ADDENDUM NUMBER: ONE (1)

DATE: May 2, 2024

PROJECT: ATHLETIC COMPLEX AT STOKES FIELD
COMMUNITY CENTER RENOVATION

DESIGNER: MONTGOMERY COUNTY ENGINEERING

C:\Users\lccummings\Documents\SSR_ELEC_STOKES FIELD BALLPARK-2020_tcumings@ssr-inc.com.rvt
 5/1/2024 12:57:47 PM
 SSR

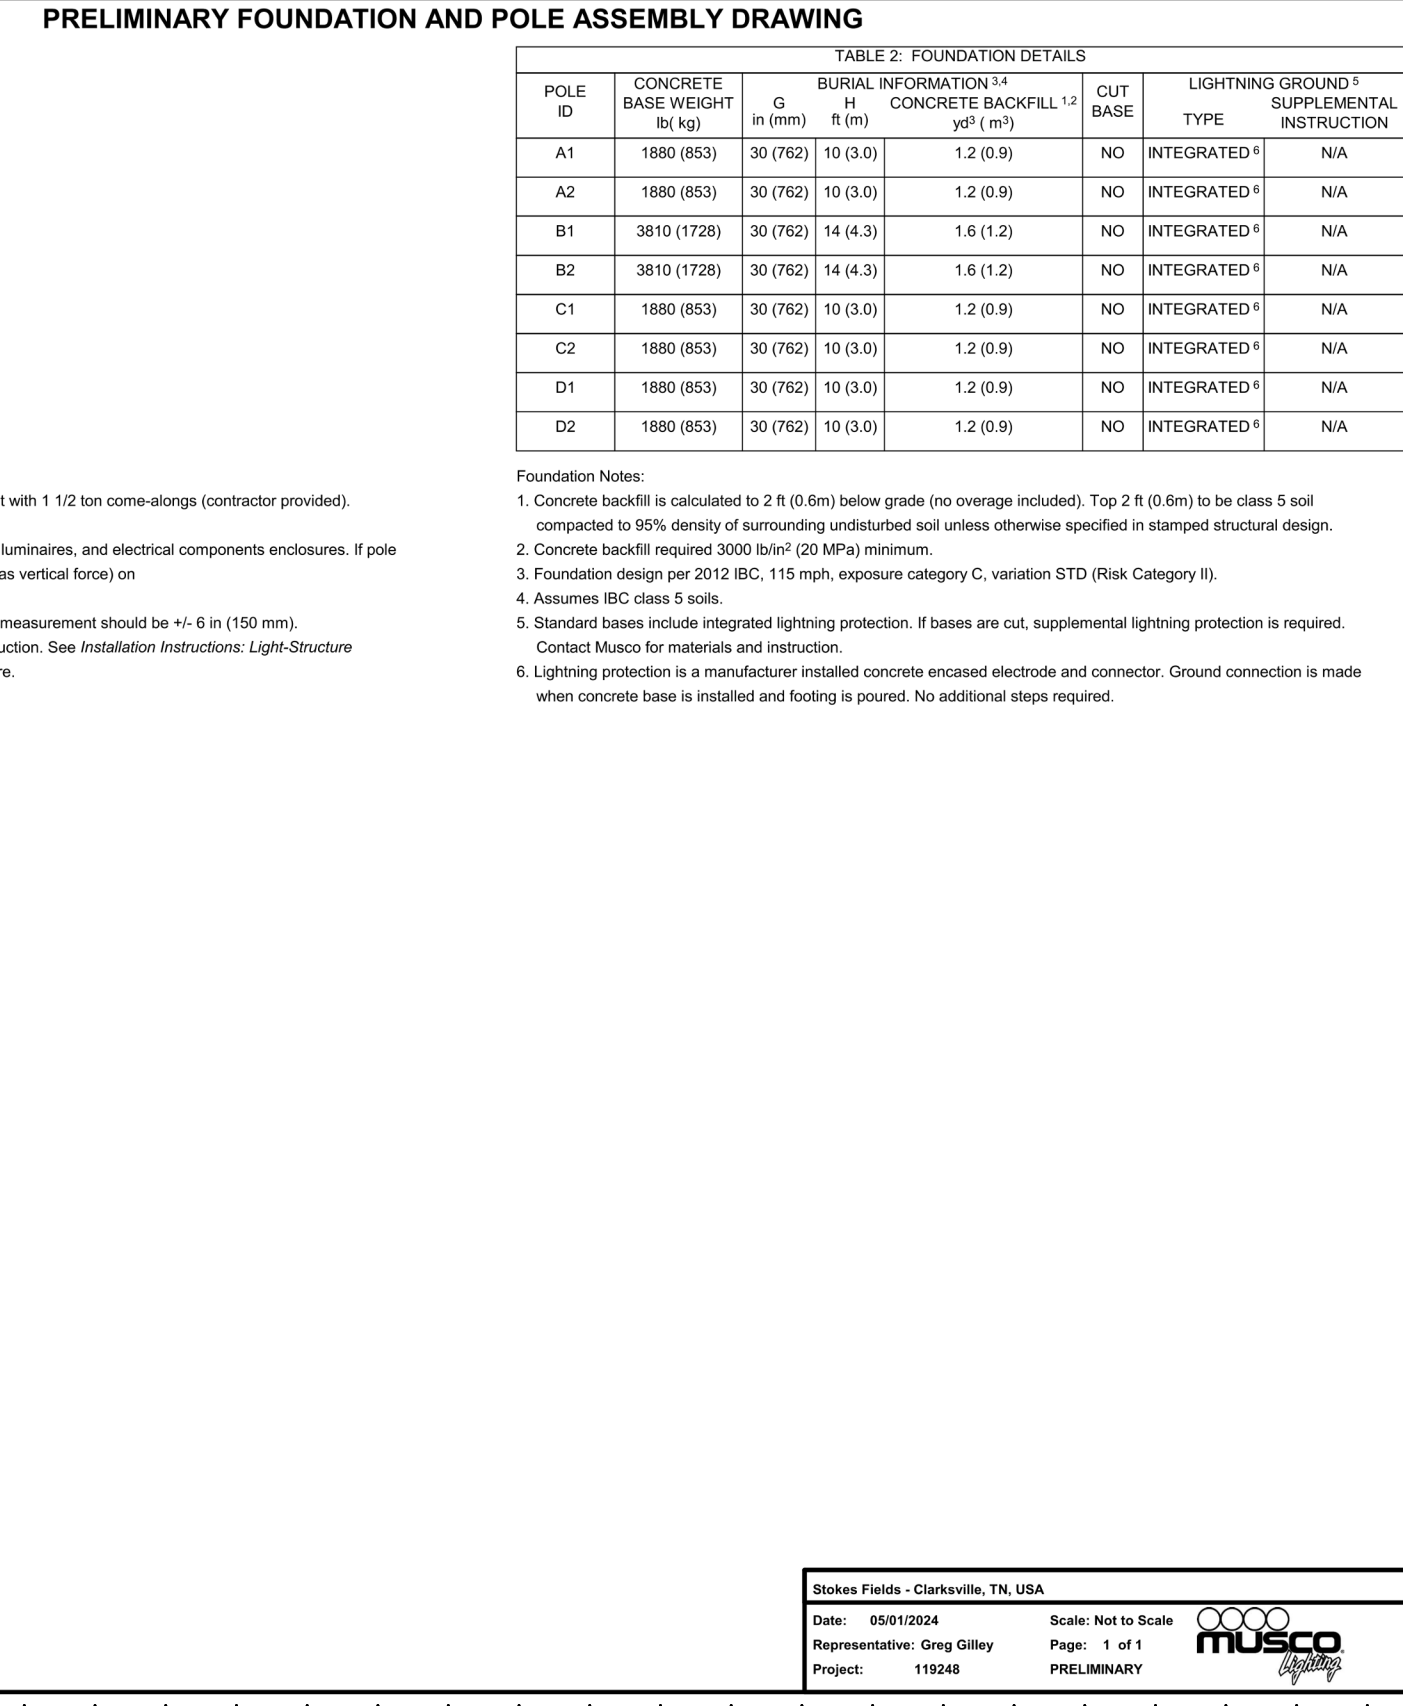
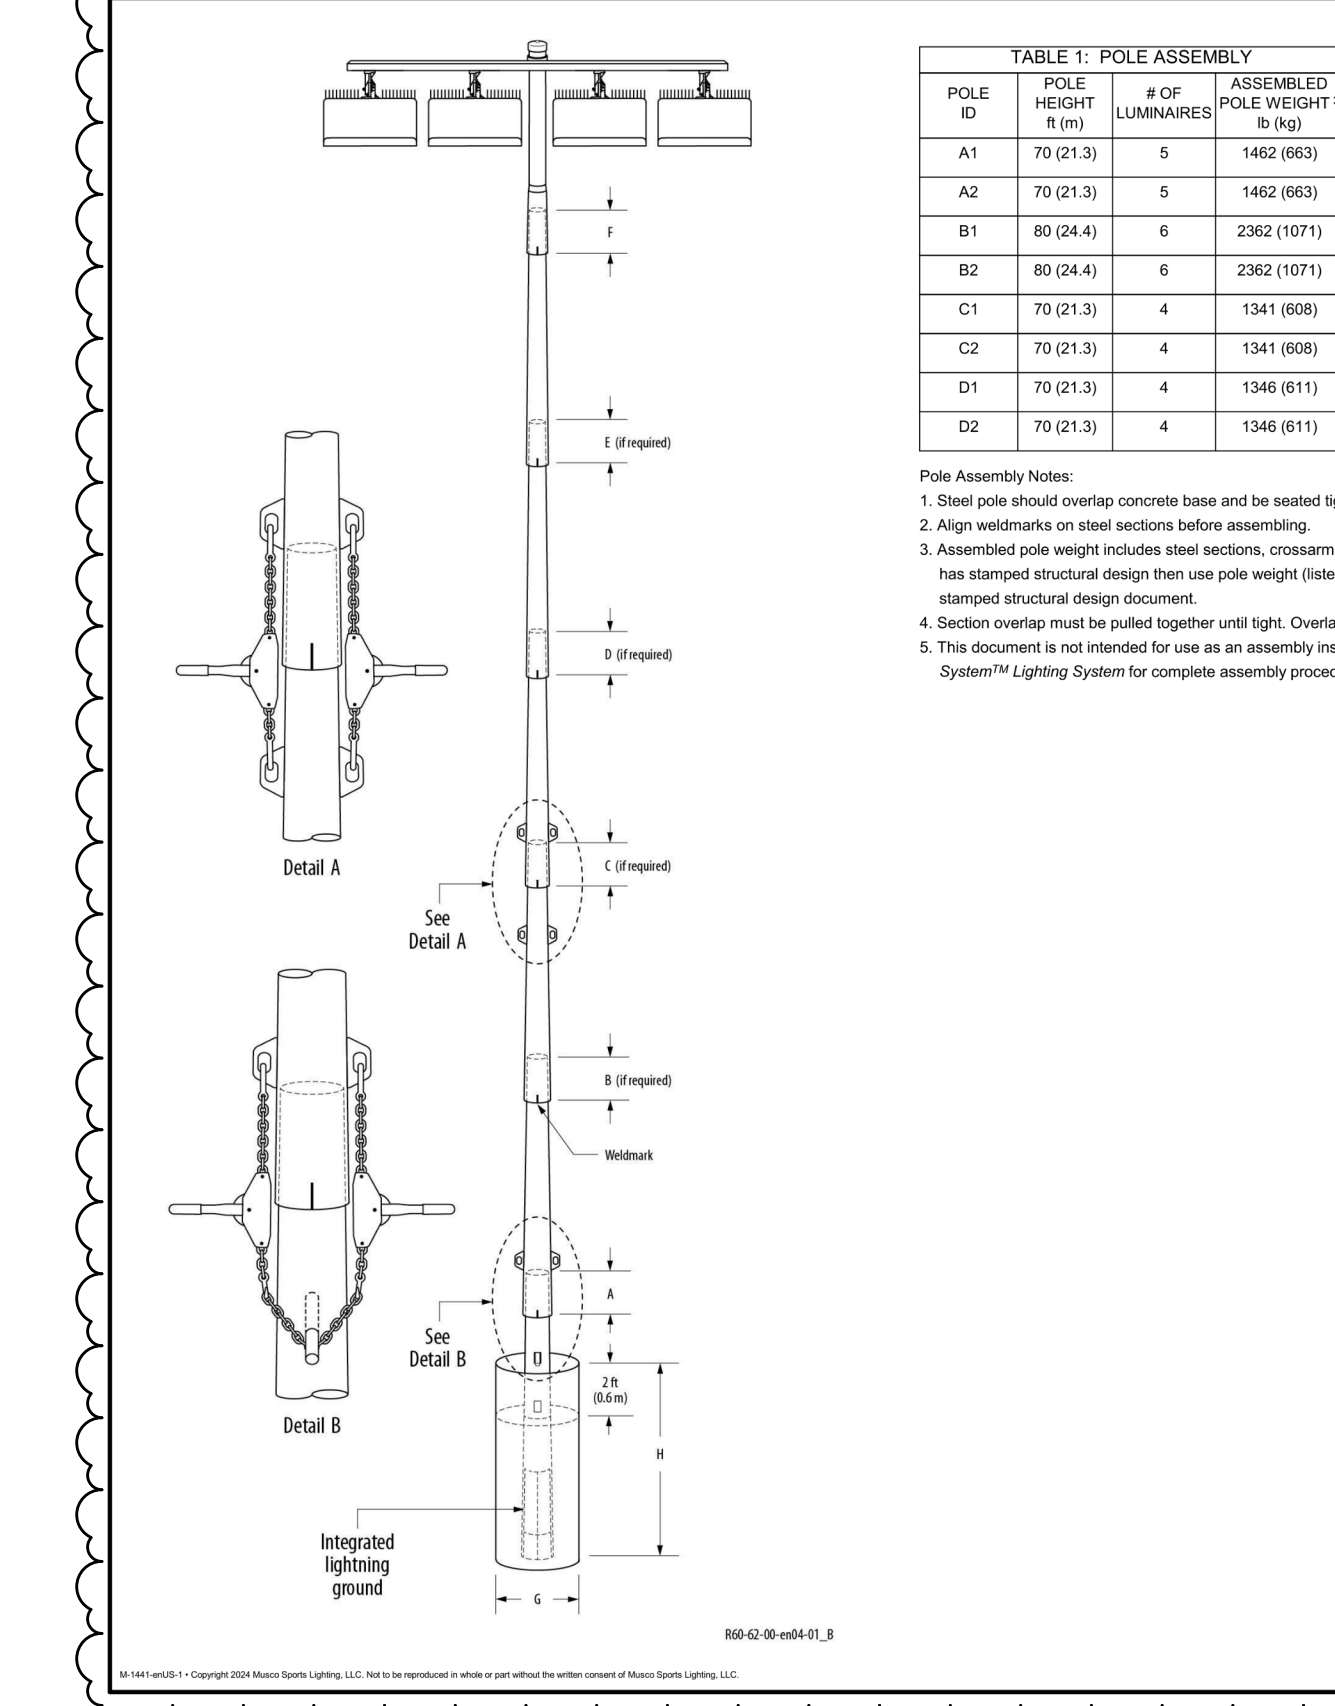
5. Drawing Sheet E5.2: Drawing E5.2 is revised and dated 4-30-24 and replaces the original E5.2. Foundation details for Field 1 poles have been added.
